An
Bord
Pleanála

Report to Inspector (Appendix to main report) R314374_App1

Substitute consent application for a
Quarry, Redcross, Co. Wicklow

**EIA: Water resources, hydrology and
aquatic environment**

Figure 1. Groundwater Elevation Contours (mOD) 2008-2022 with trendlines

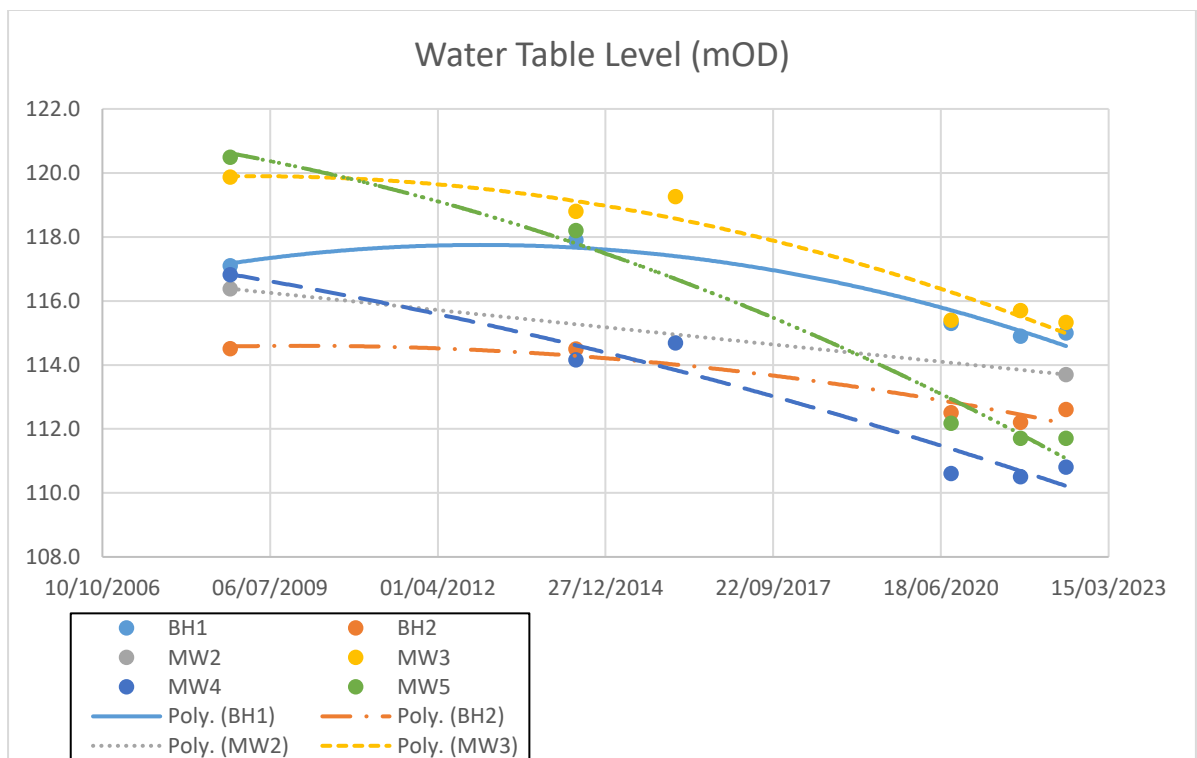
2.2.2 The magnitude of change in the boreholes varies depending on distance from the deepest excavated area in the NW of the site. The boreholes closest to the deep excavation area (MW4 and MW5) demonstrate the largest drop in groundwater levels from 2008 to 2022 (see table 1). This highlights the drop in groundwater within the deposits of sand and gravel in the eastern and central part of the quarry. Groundwater levels in BH1 and BH2 have been impacted less despite being similar distances from the deep excavation as MW4 and MW5 which indicates the groundwater levels in non-sand and gravel deposits have not been impacted to the same extent.

Figure 2. Groundwater Elevation Contours (mOD) 2022 with Borehole locations (Golder, 2023)

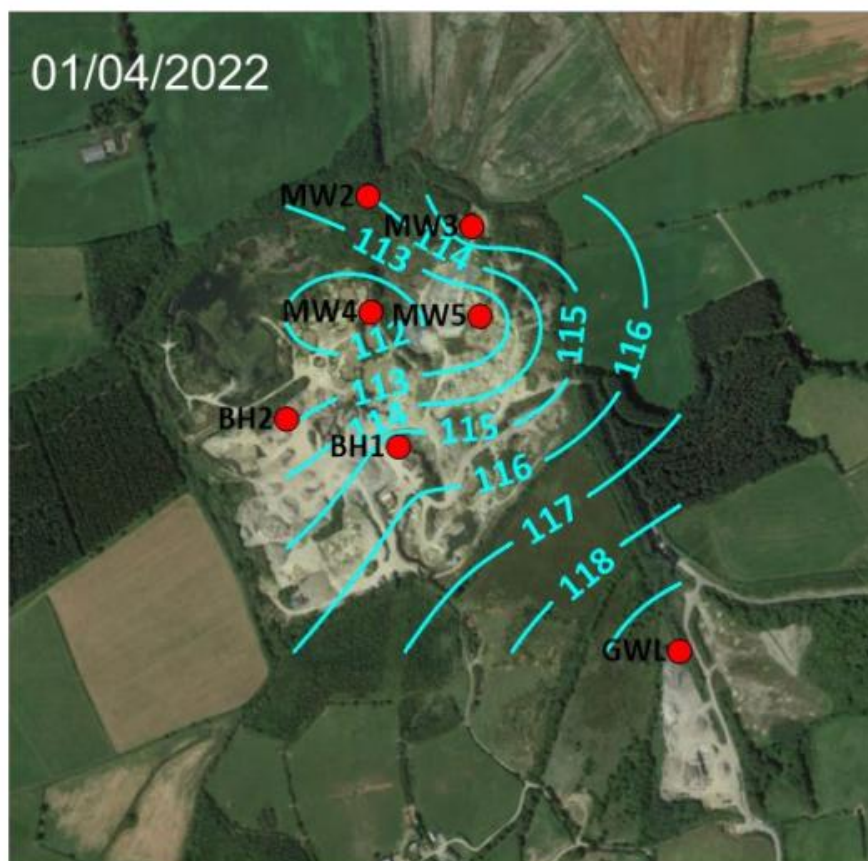
The rEIAR reports that any changes in groundwater levels during the period of review resulting from activities relating to the operation of the site are of low magnitude, direct, short term and reversible. I am satisfied that the rEIAR provides sufficient information to make a robust decision regarding the quantity of groundwaters and I agree with this conclusion. These measured changes in water levels within the quarry are normal for a dewatered sand and gravel quarry operation.

Figure 3. Total Ammonia (as N) at RS10A050400 for the period 2007 – 2020

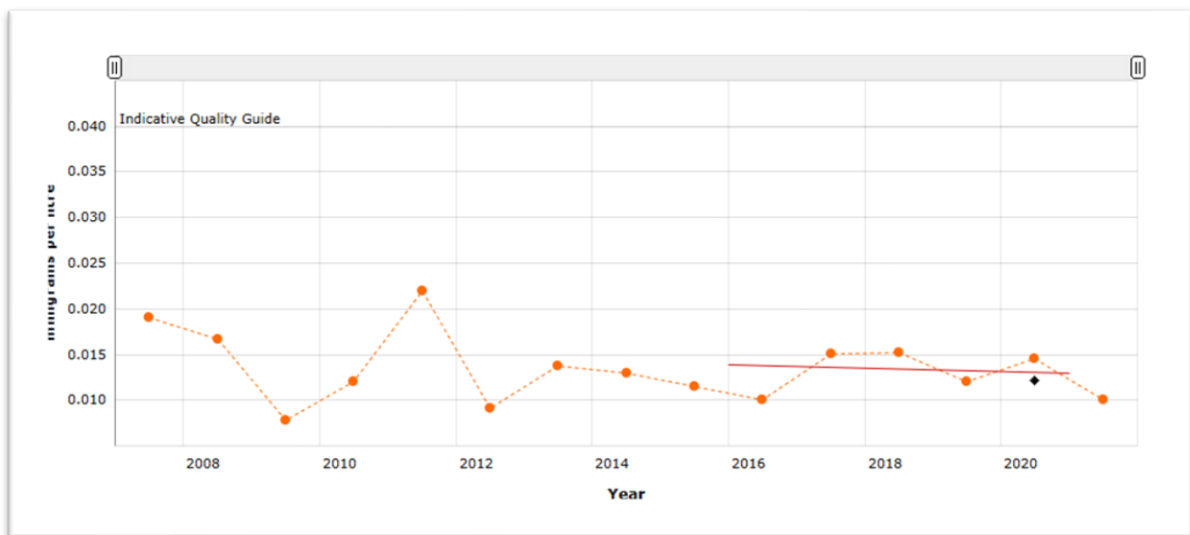
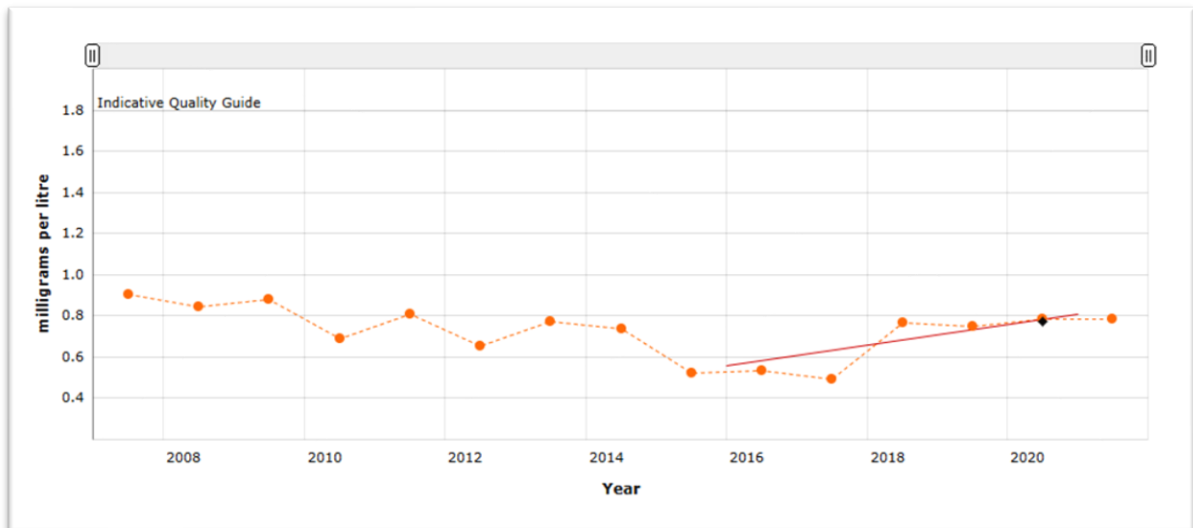
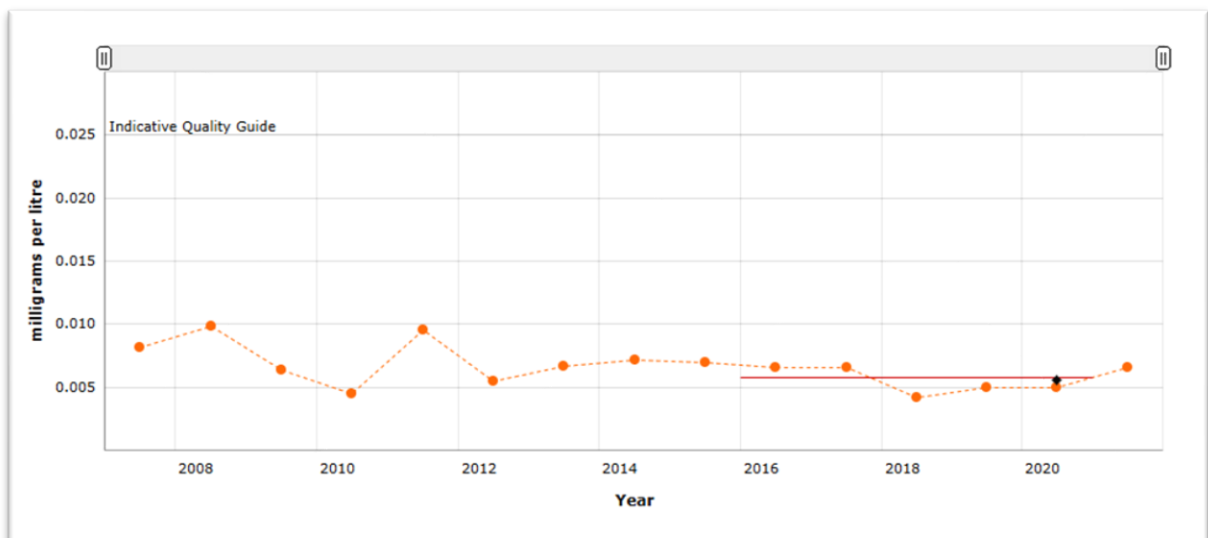
Both Ammonia (Total) and ortho-Phosphate readings are indicative of High-Status quality ($\leq 0.040\text{mgN/L}$ and $\leq 0.025\text{mgP/L}$ respectively) and demonstrate a downward trend. Total Oxidised Nitrogen readings indicate Good-Status conditions and an upward trend. I have reviewed the EPA database for surface water quality at this location and can also confirm that Dissolved Oxygen, Biochemical Oxygen Demand and Suspended Solids data show that these parameters have indicated water quality of Good or High Status in the period 2007 - 2020.
